Subject:
Battle Street - Response to
Condition 30

The following information has been prepared to discharge Planning Condition 30 of Planning Application 22/1405 for the Land at Battle Street, Reading. The SuDS design and associated maintenance requirements follow the principles of the approved scheme which was granted permission 7th September 2023.

Comments from LLFA and Landscape Officer:

Proposed Below Ground General Arrangement Plan (1 of 2) – BAT-EWP-ZZ-00-DR-10000

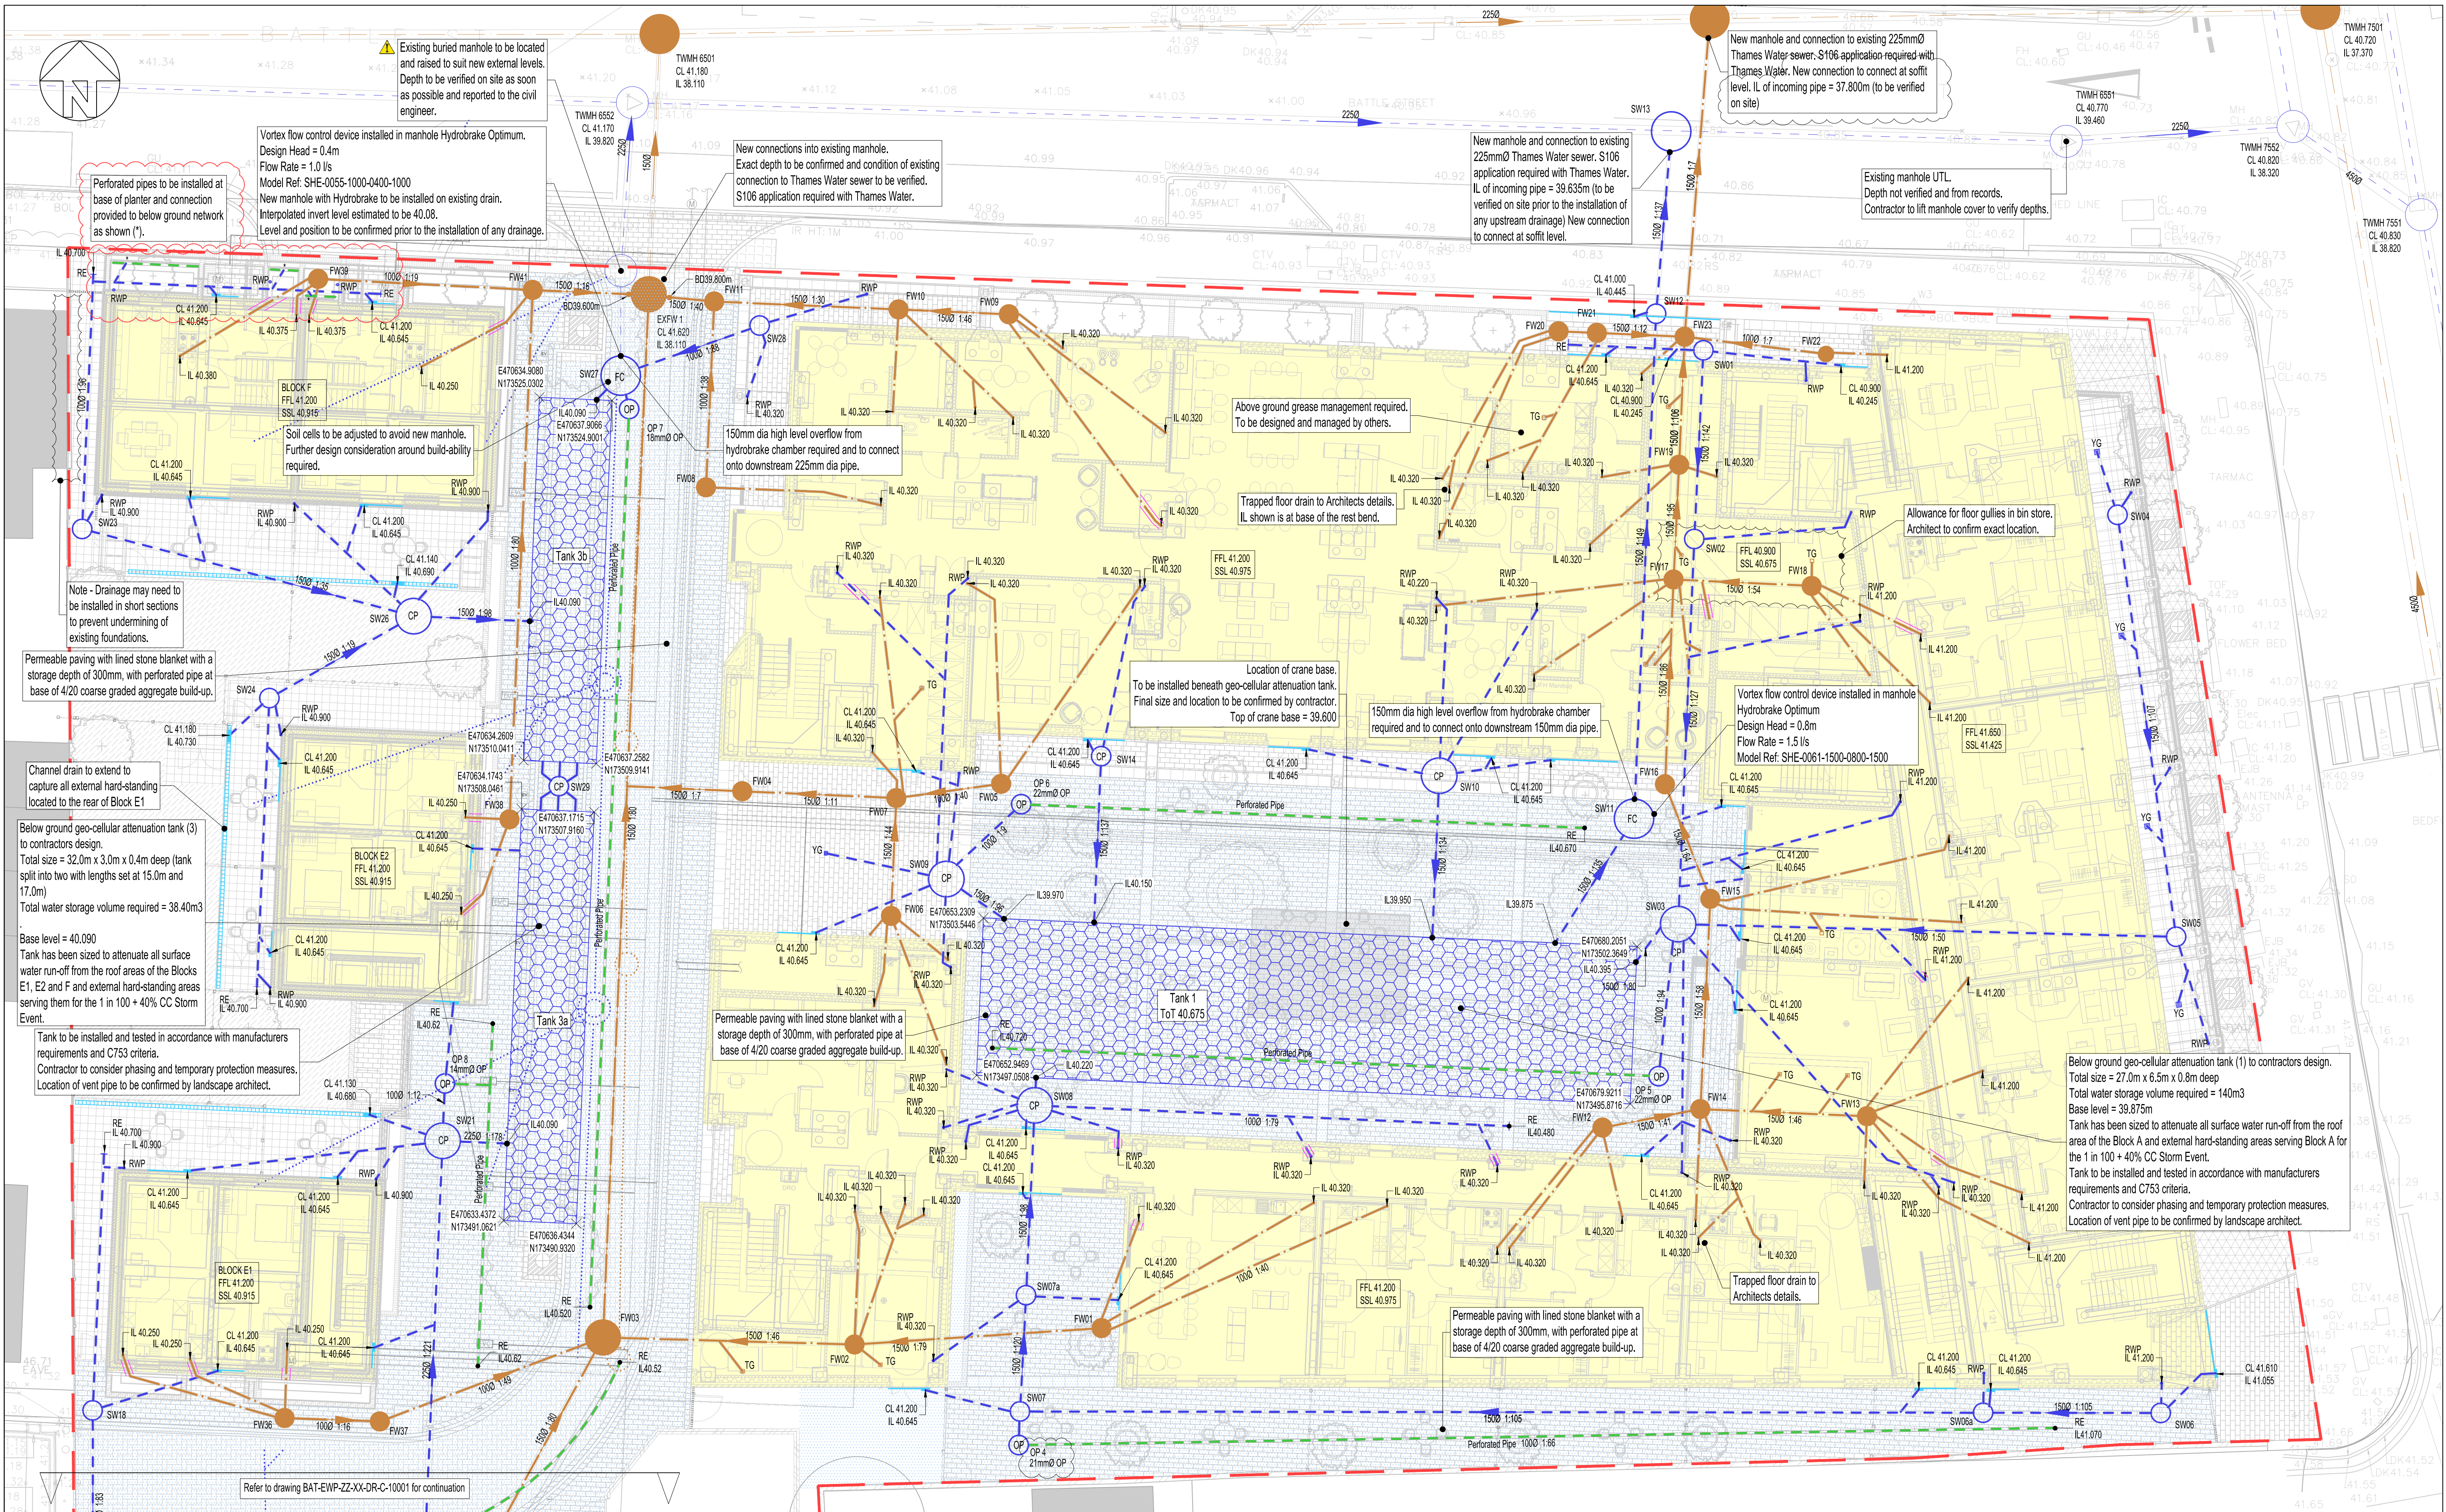
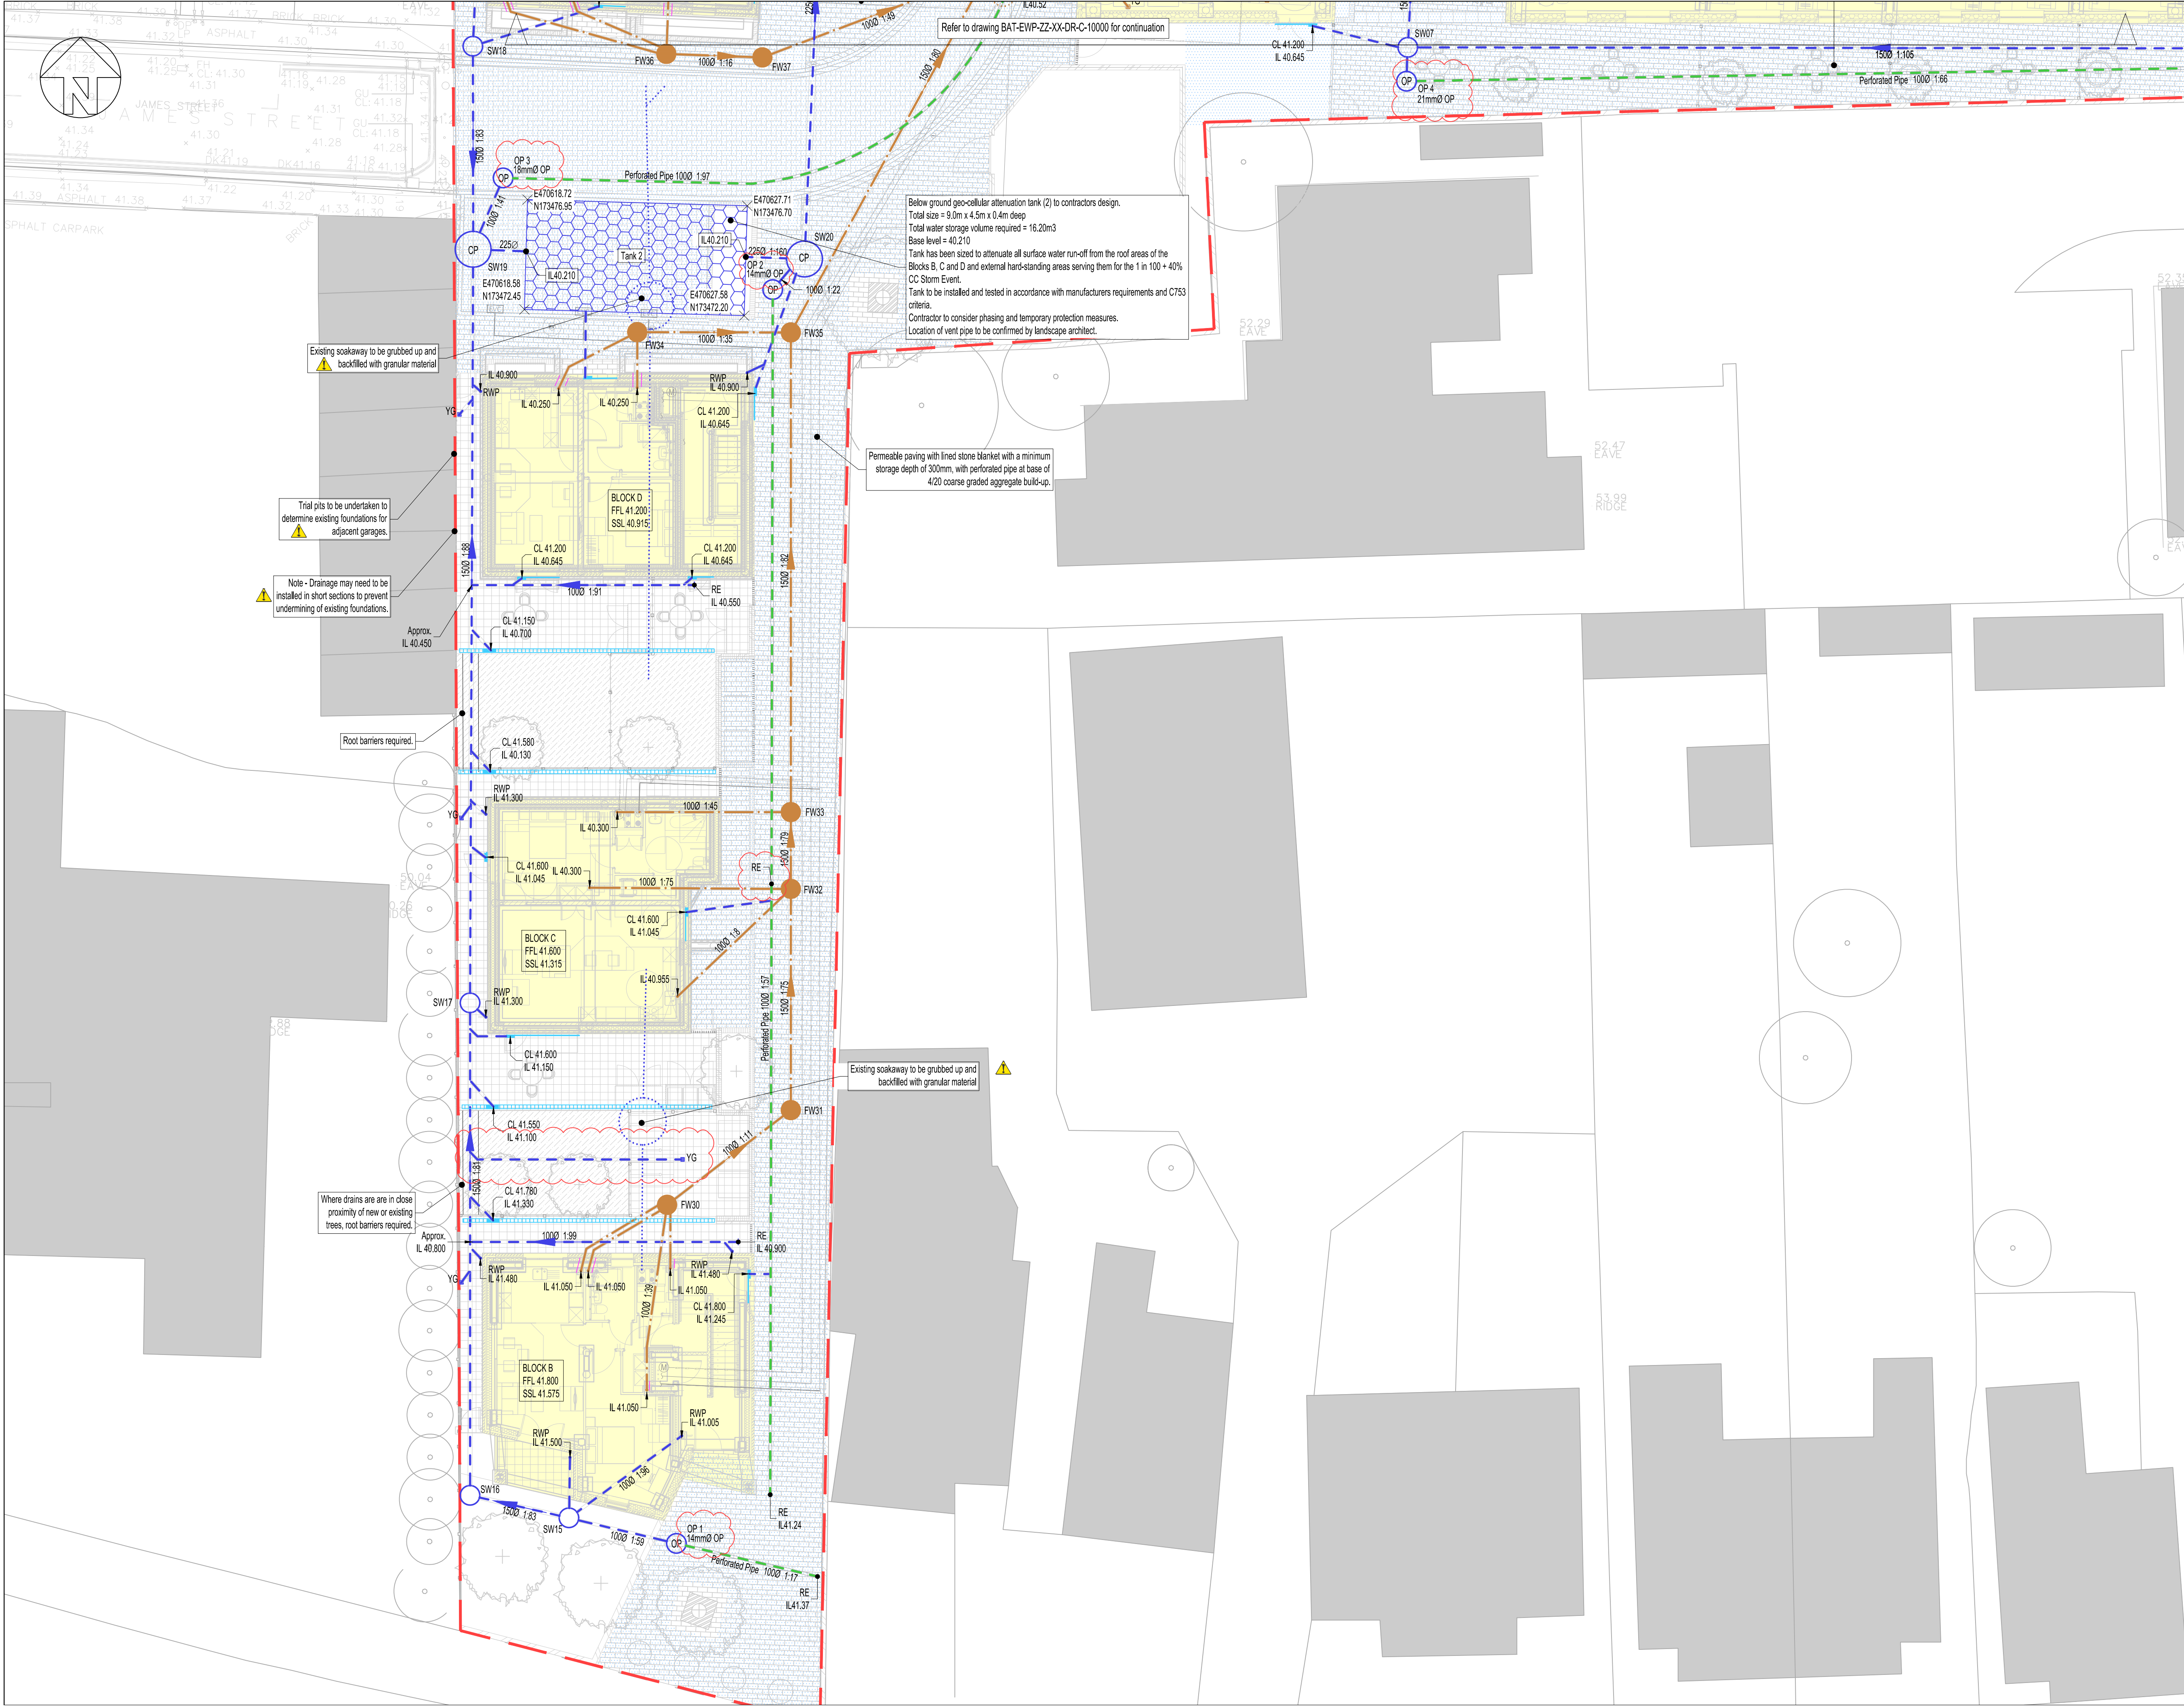
Comment 3: *the proposed drainage system should include connection to the on-site landscaping*

Response: measures in connection with the irrigation of the landscaping have been provided as far as possible:

- Use of permeable paving, to allow infiltration, as shown on drawings BAT-EWP-ZZ-00-DR-10000 and 10001
- Perforated drainage downpipes to be installed at base of planter and connected to below ground network, as shown on drawings BAT-EWP-ZZ-XX-DR-C-00001 – Typical Raised Planter Section

1 Blocks C & E2 - Timber Roof Parapet Detail (sedum)
1 : 5

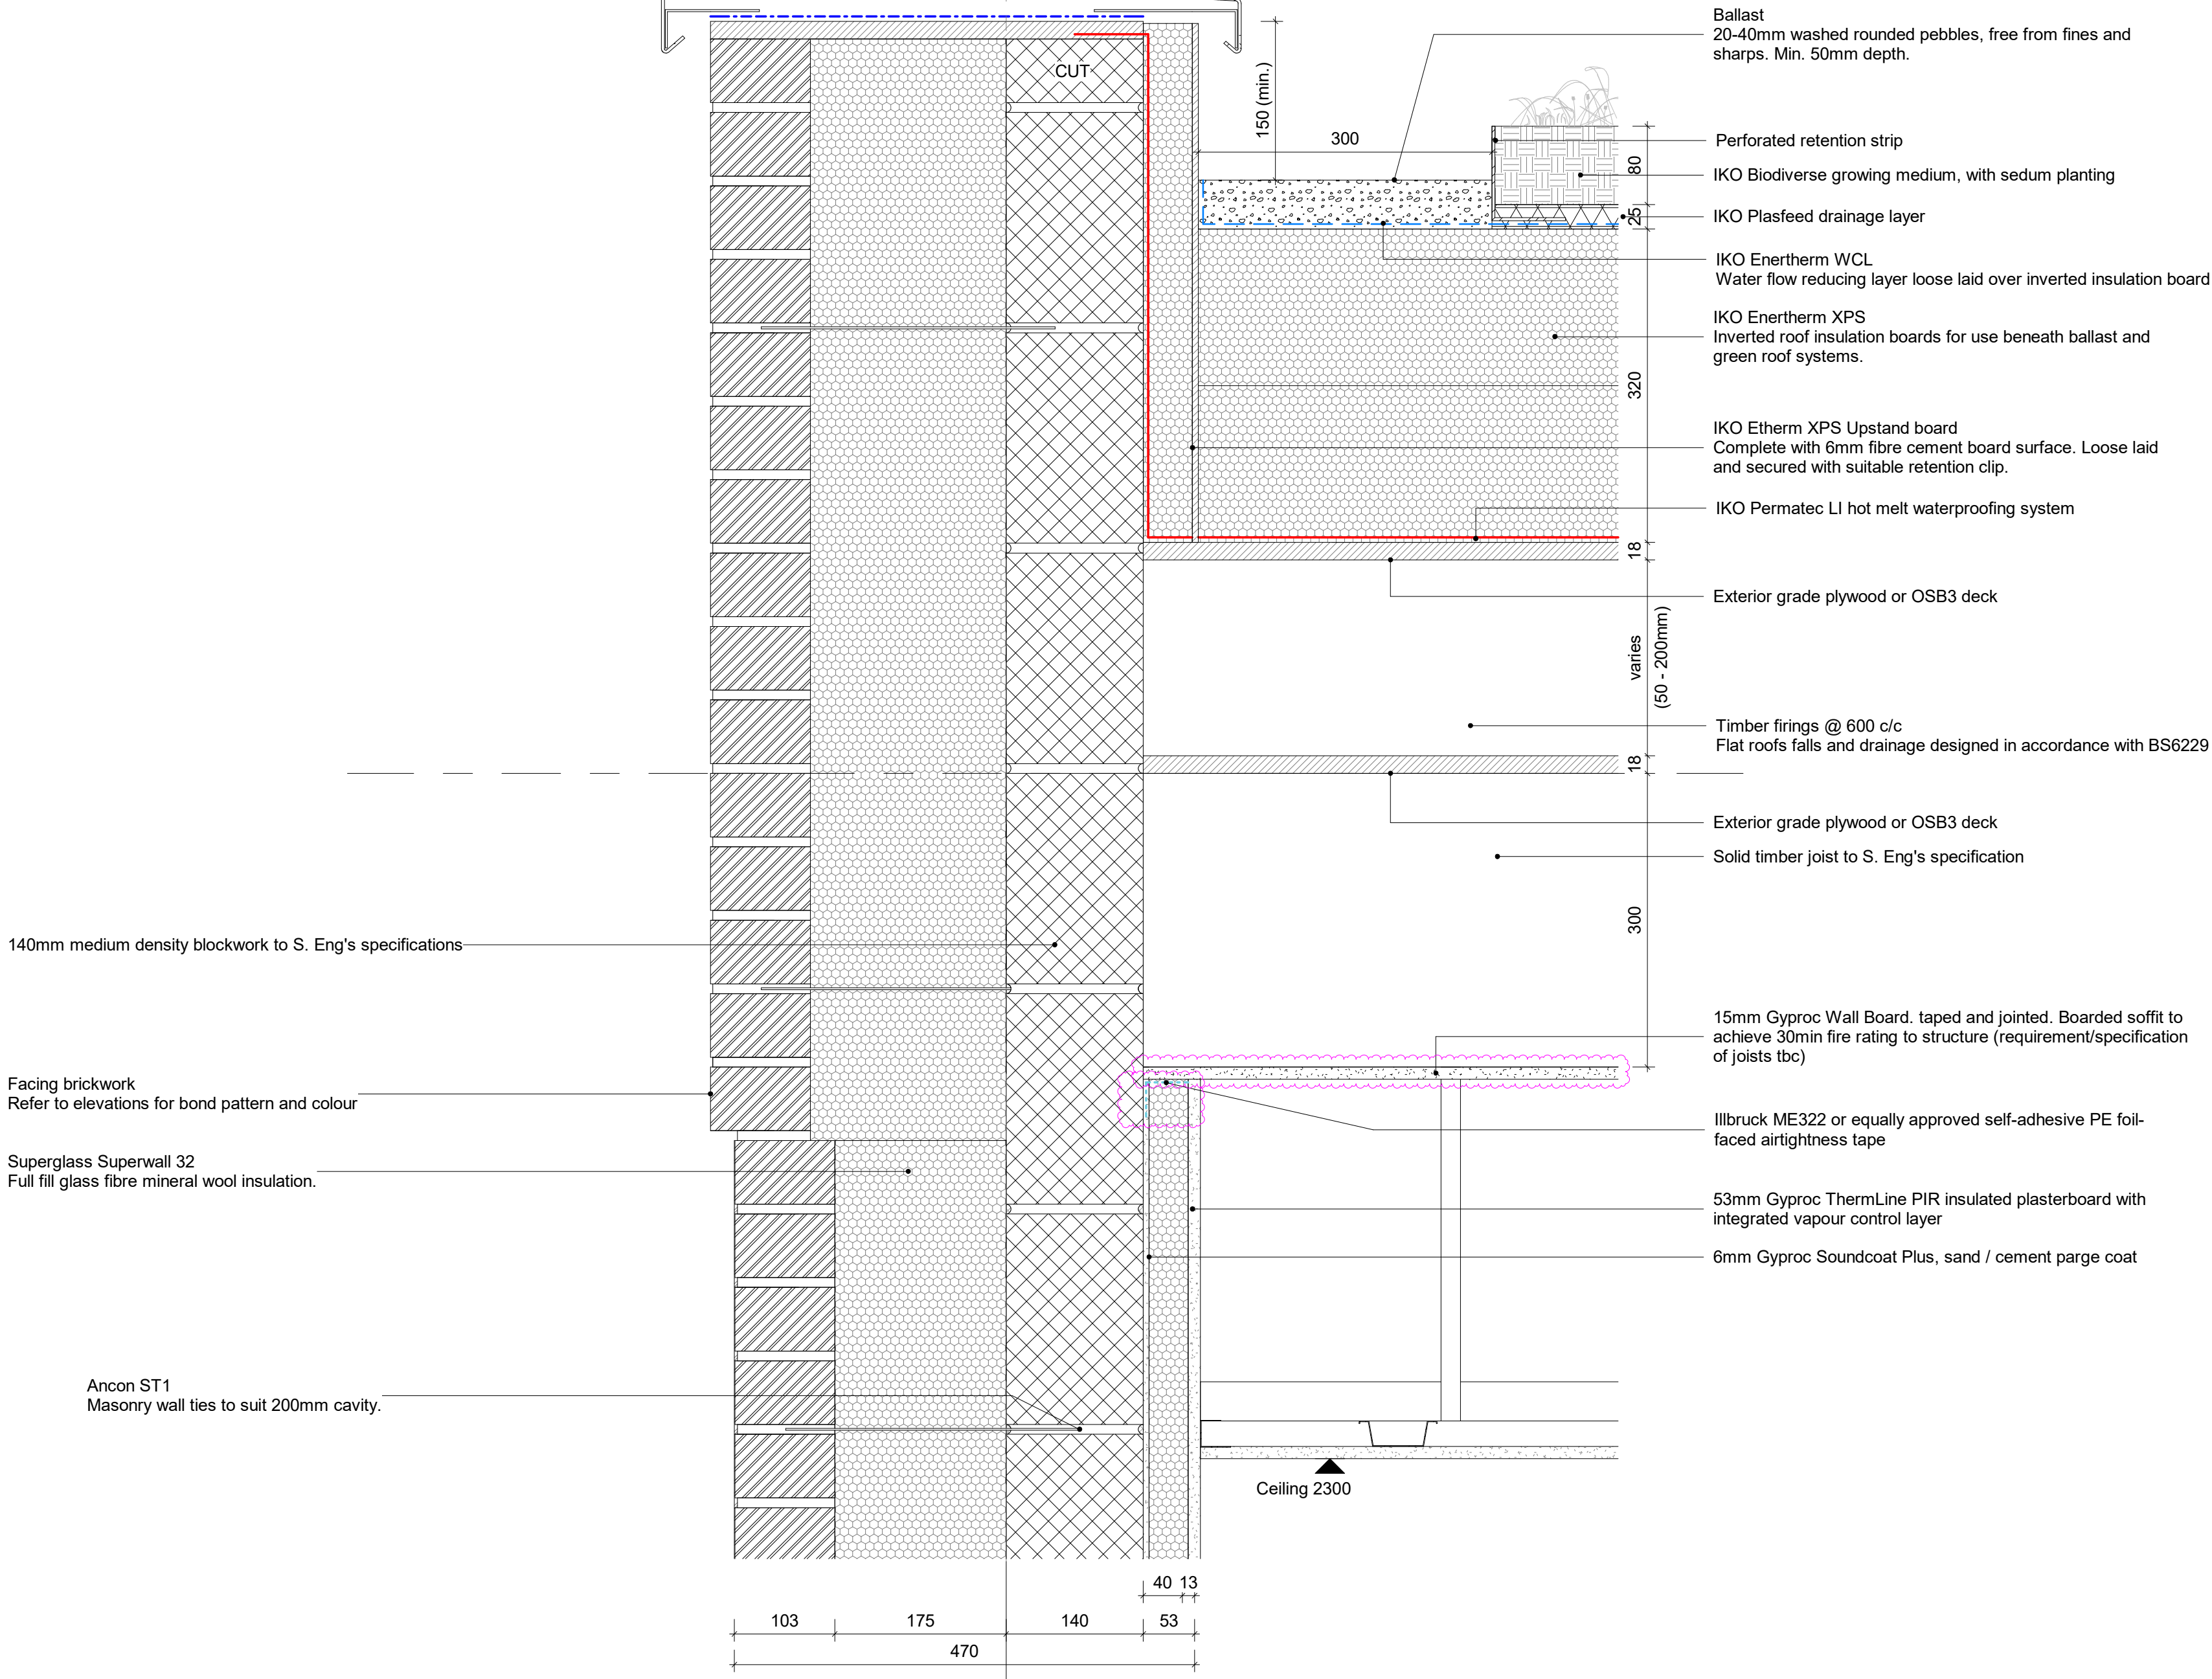
Comment 1: *a green roof has not been provided on any of the submitted drawings*

Response: a green roof is shown on drawings referenced below:

Block A – Main Roof to Ext. Wall Parapet Detail – BAT-BBA-XX-XX-DR-A-31110
Block C & E2 – Timber Roof Parapet Detail (Sedum) – BAT-BBA-XX-XX-DR-A-31403
Roof Types – BAT-BBA-XX-XX-DR-A-31003
